ADDENDUM

Project: **Crestwood School District
Cherry Hill Baptist Church
Administration Relocation and Addition**

Date: **August 15, 2023**

Addendum Number: **#002**

1 ROOF FRAMING PLAN

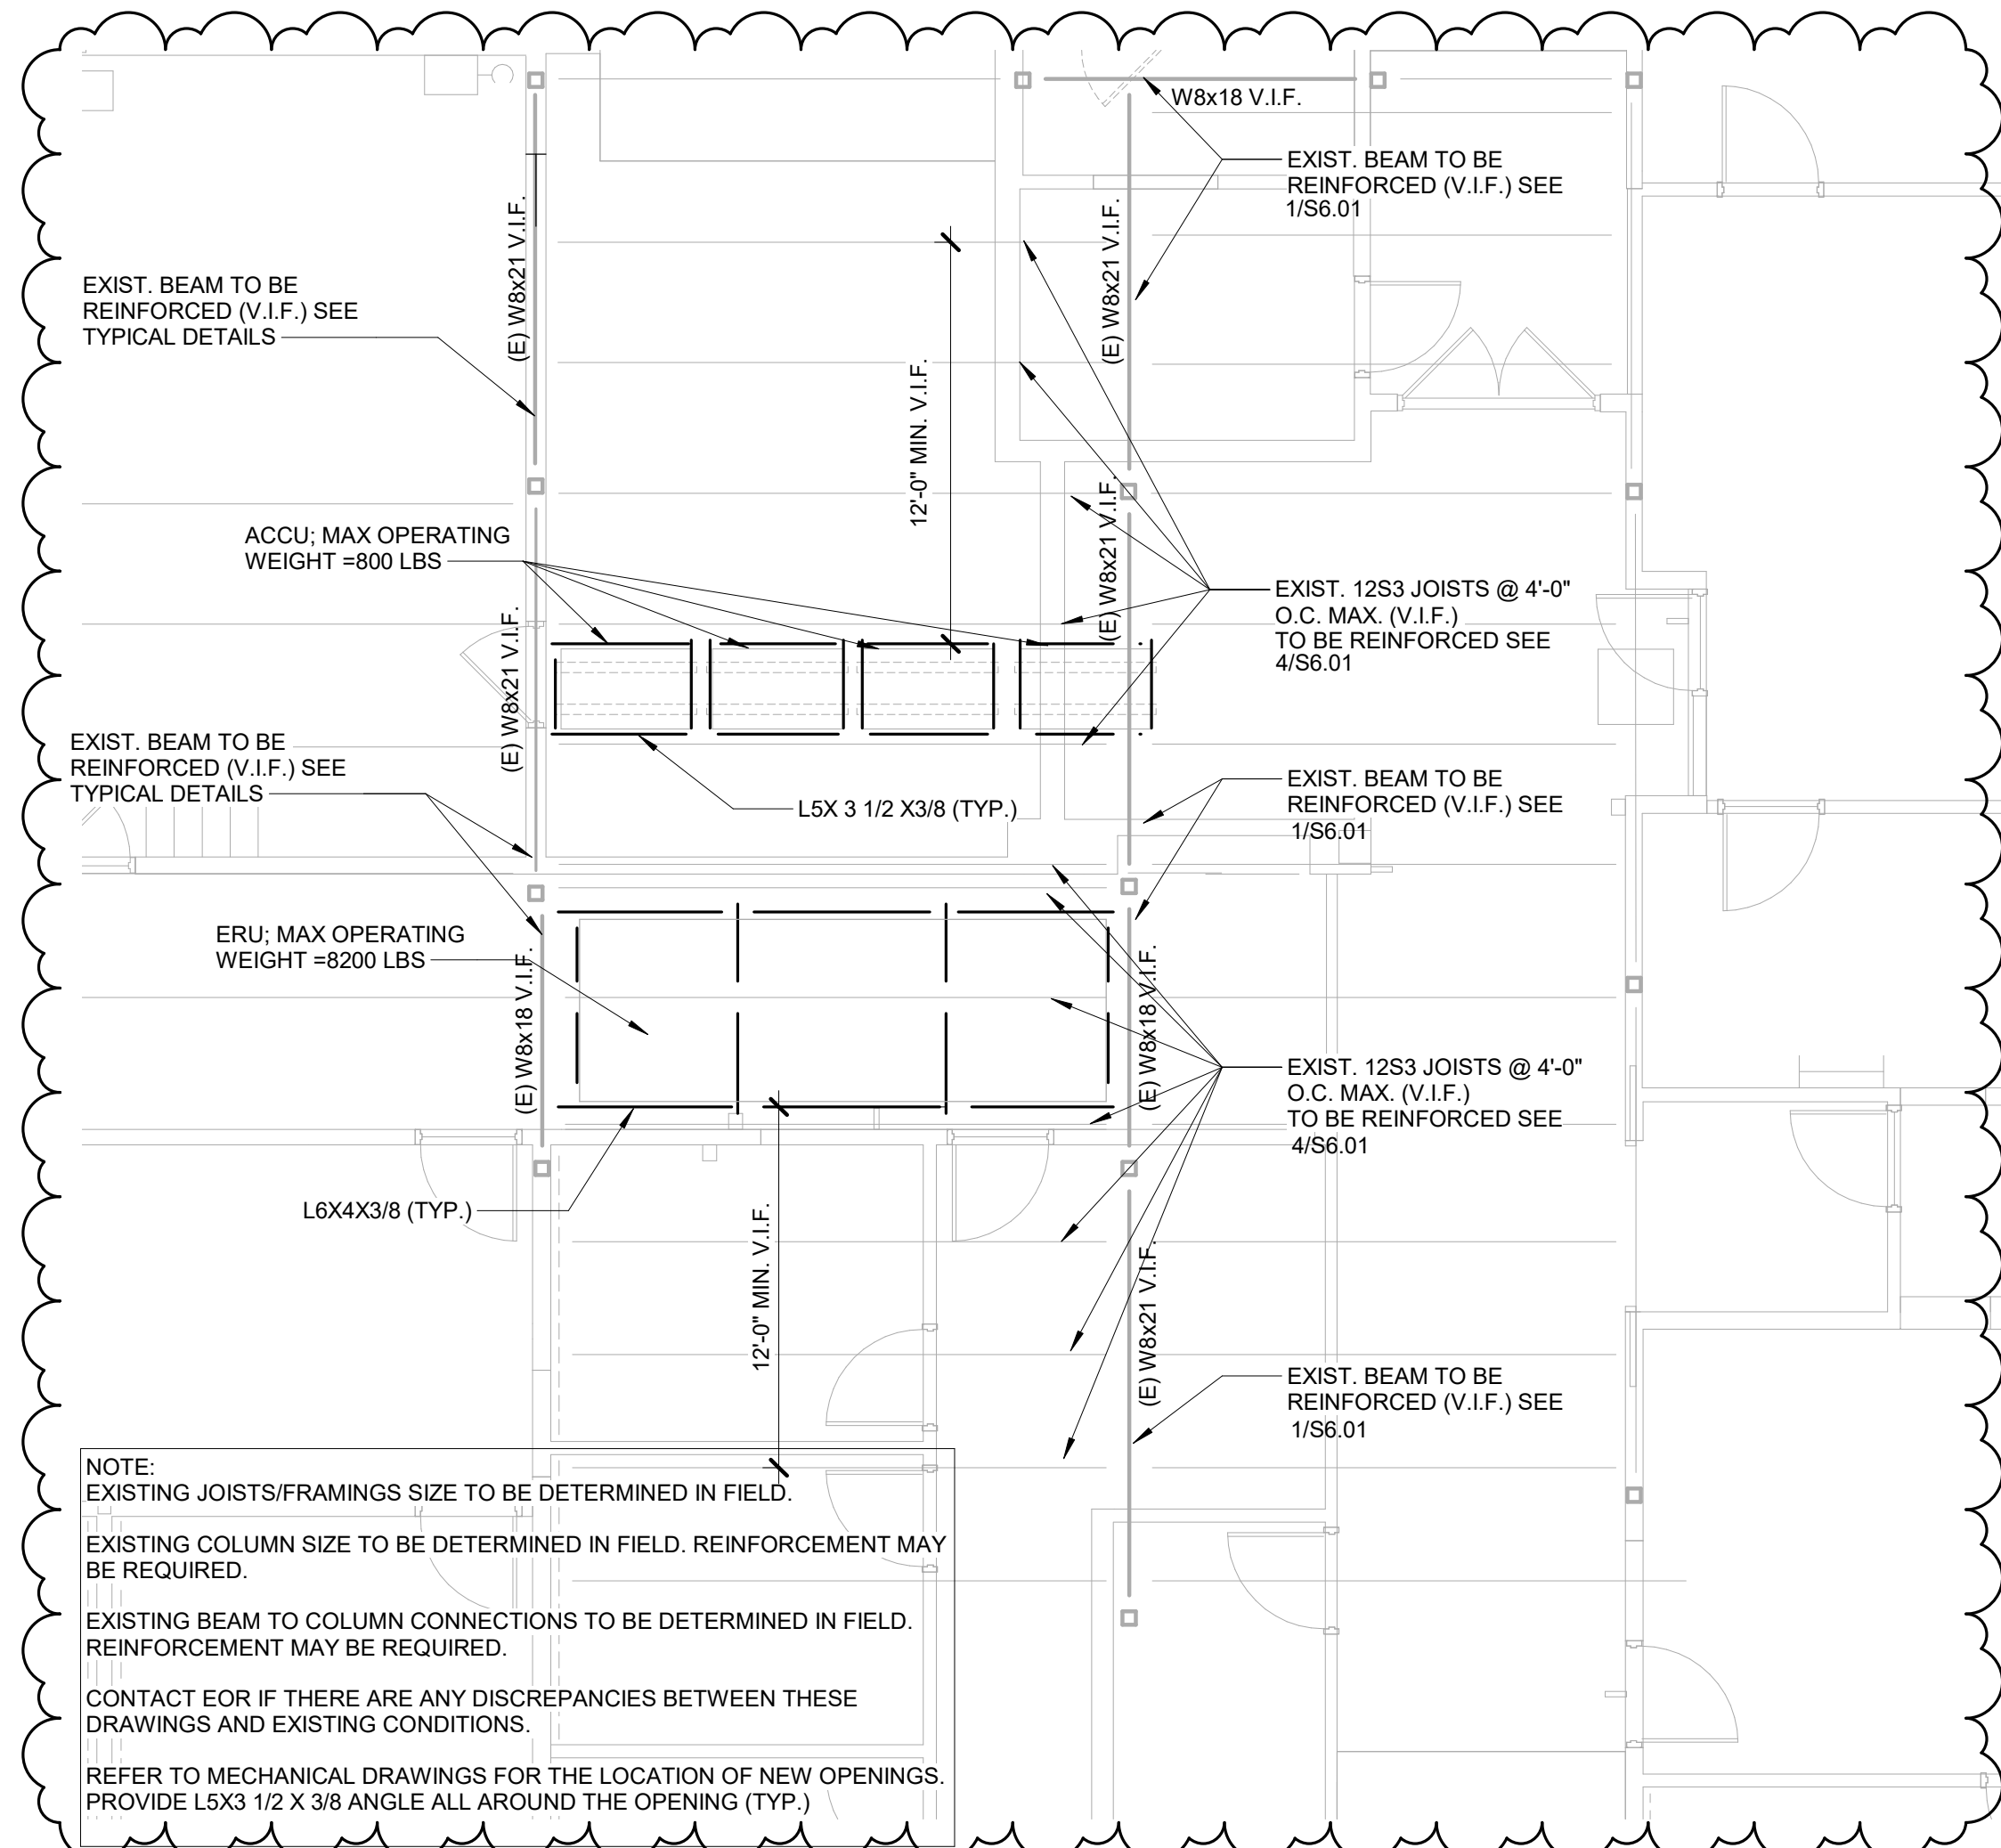
S2.11 – Roof Framing Plan

REVISE: Refer to clouded areas for drawing revisions.

TYPICAL MASONRY SECTIONS

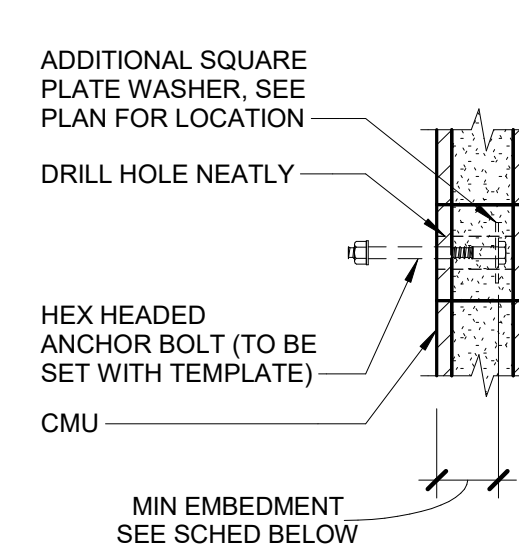
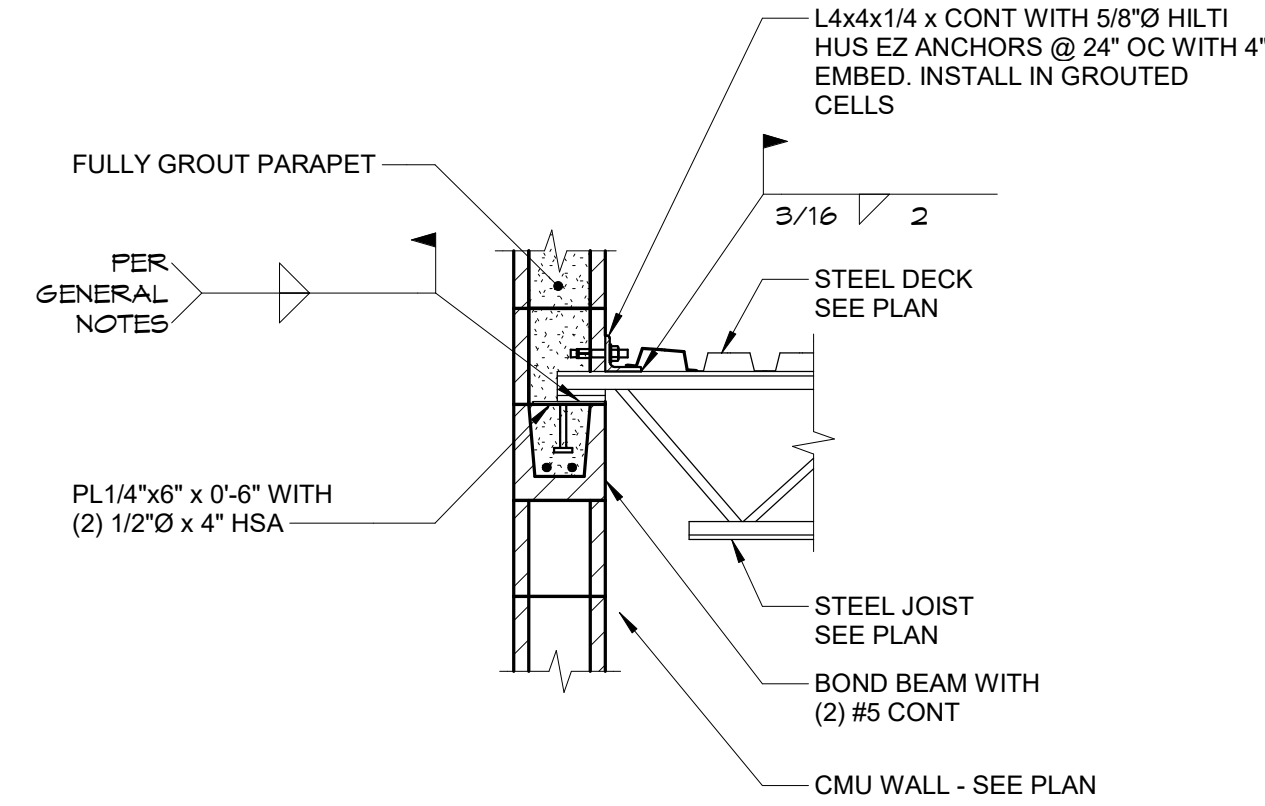
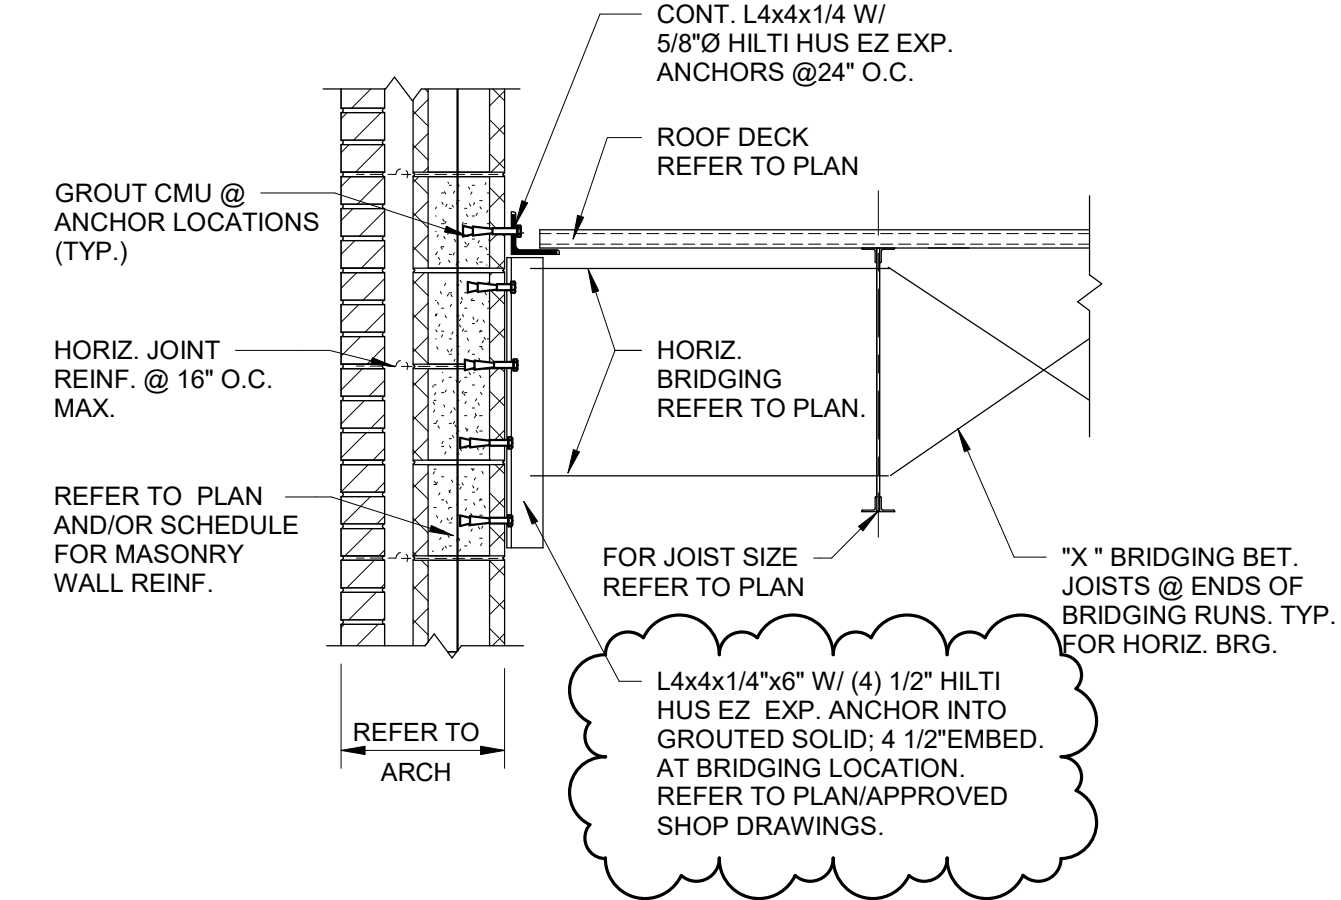
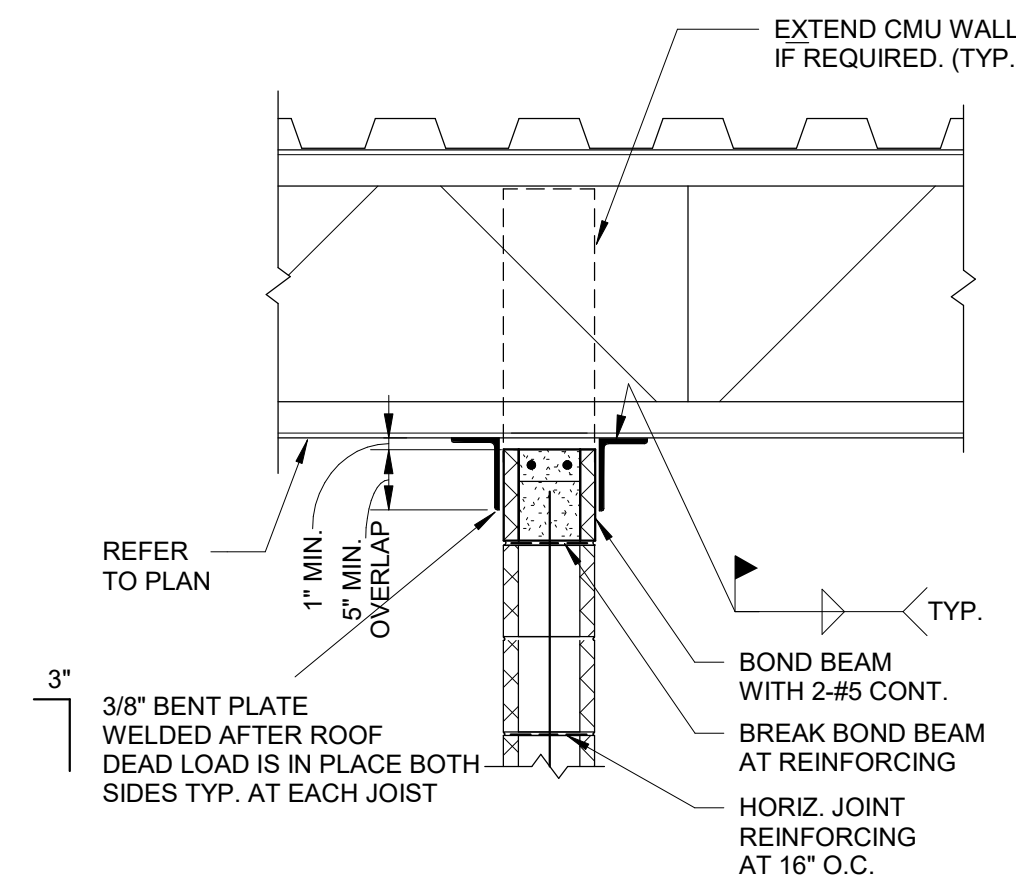
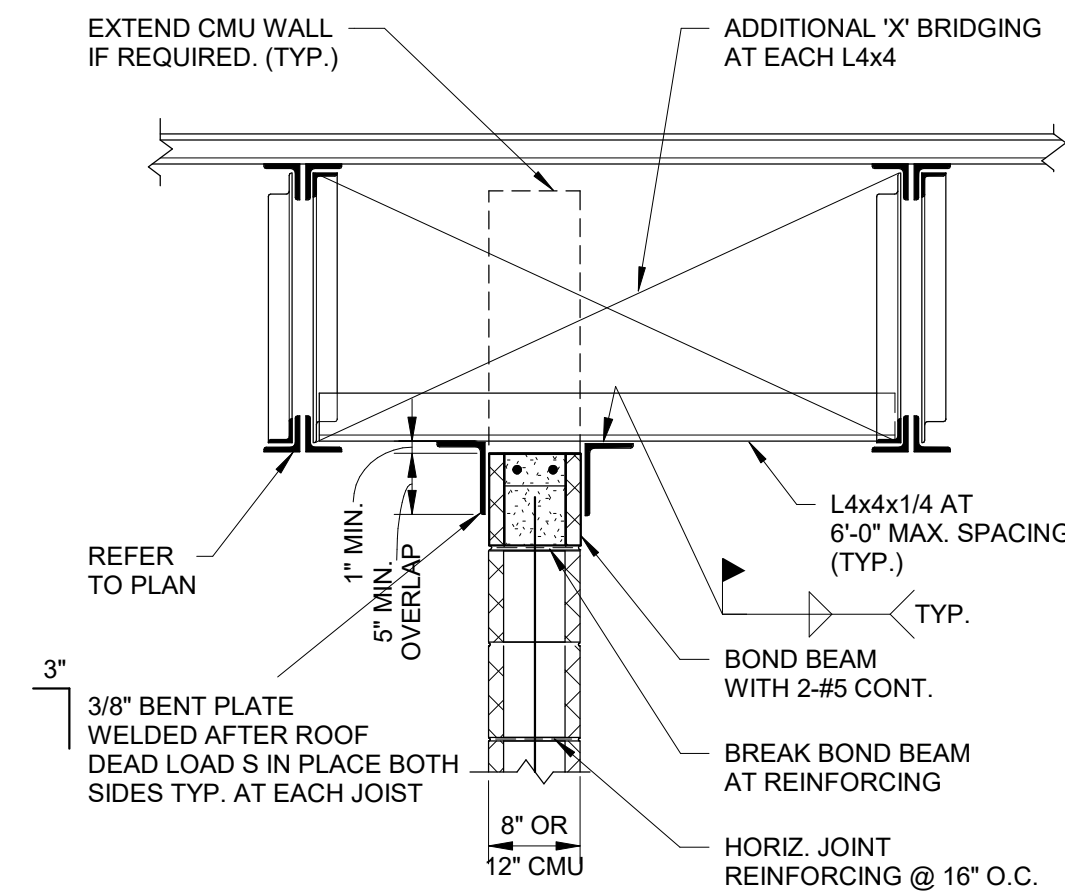
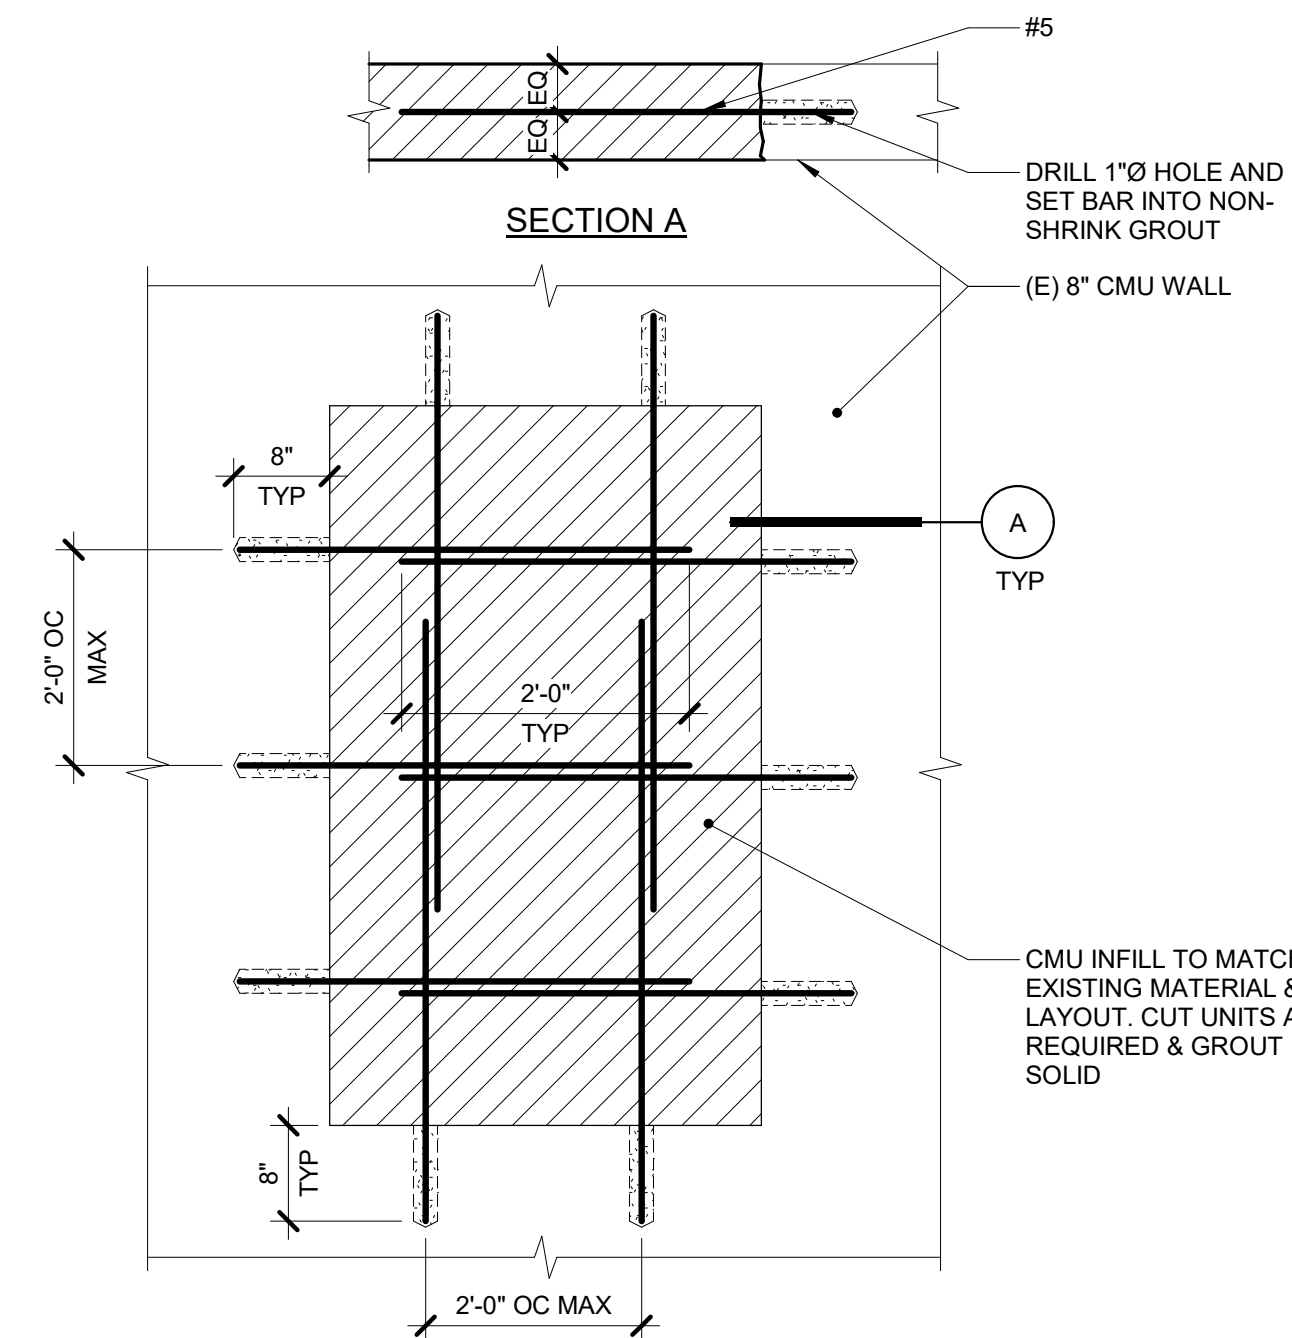
S4.01 - Typical Mansory Sections

REVISE: Refer to clouded areas for drawing revisions.
